UNITED STATES PATENT AND TRADEMARK OFFICE

APPLICATION NO.	FILING DATE	FIRST NAMED INVENTOR	ATTORNEY DOCKET NO.	CONFIRMATION NO.
10/048,165	01/29/2002	Martin Caldwell	741890-0023	4375

Office Action Summary

DETAILED ACTION

Fig. 2B

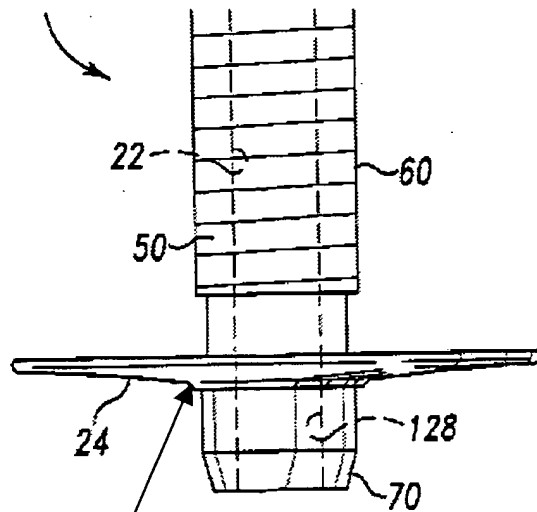
14. Regarding Claim 18, the entry port (central hole in seal 24) has a conical section, as is evident in the below drawing:

Conical
flange
